No. 0253-151

**SUBJECT:** AILERON AND AILERON TAB CONTROLS, INSTALLATION OF AN IMPROVED AILERON CENTERING CABLE

**AIRCRAFT AFFECTED:** BEECHCRAFT Musketeer Model A23A, and B23, serials M-963 through M-1284; Model A23-24, serials MA-28 through MA-361 and MA-368; Model A23-19 and 19A, serials MB-1 through MB-461.

FIGURE 1

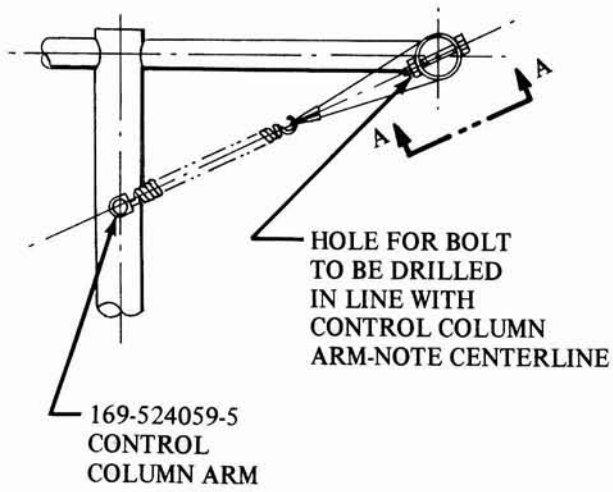
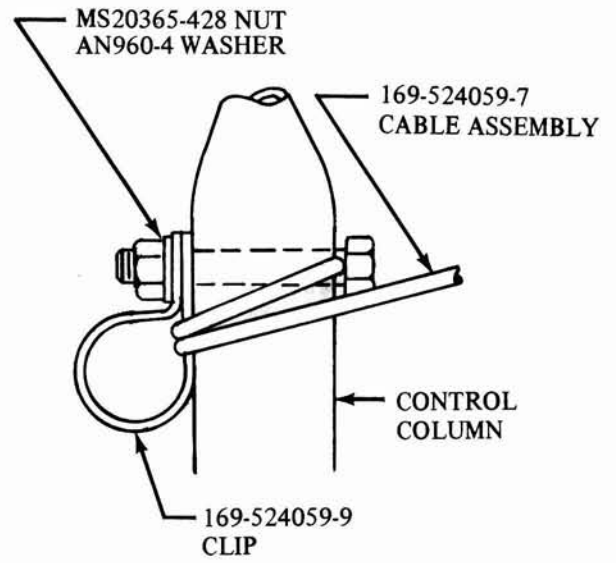
The aileron centering cable assembly for current production BEECHCRAFT Musketeers incorporates a longer aileron centering cable assembly, P/N 169-524059-7, and an improved method of installation. When it is necessary to replace the existing aileron centering cable on the aircraft noted above, the longer cable assembly, P/N 169-524059-7, may be used as a replacement for the original cable assembly, P/N 169-524059-3. This modification may be accomplished as follows:

2. Install the bolt attached to the centering cable from the bottom inboard side of the aileron control wheel column, with the 169-524059-9 clip, AN960-4 washer and MS20365-428 nut installed on the top outboard side of the column as shown in figure 1 view A-A.

1. Drill a .250/.254 hole in the control column to accommodate the AN4-16A bolt used in the new 169-524059-7 cable assembly. The hole should be 2.25 inches aft of the forward end of the control column tube

and drilled to align with the existing hole in the vertical control column when the wheel is in neutral as shown in figure 1.

1. Lock the aileron controls in neutral with the control lock pin or a 1/4 inch bolt.

3. Adjust the cable so that equal tension is obtained on each side of the centering cable and tighten the nut to prevent slippage. Caution must be used to prevent over tightening of the nut which may result in crushing the centering cable.

2. Discard the 100942S0416-62 spring, and the 169-524000-35 clip and 169-524000-47 arms.

3. Install a new 169-524059-5 arm to the vertical control column in lieu of the 169-524000-35 clip.

4. Install the new 100942S0316-50 spring to the 169-524059-5 arm.

5. Install the new 169-524059-7 cable assembly and 169-524059-9 clip as set forth in the preceding instructions.
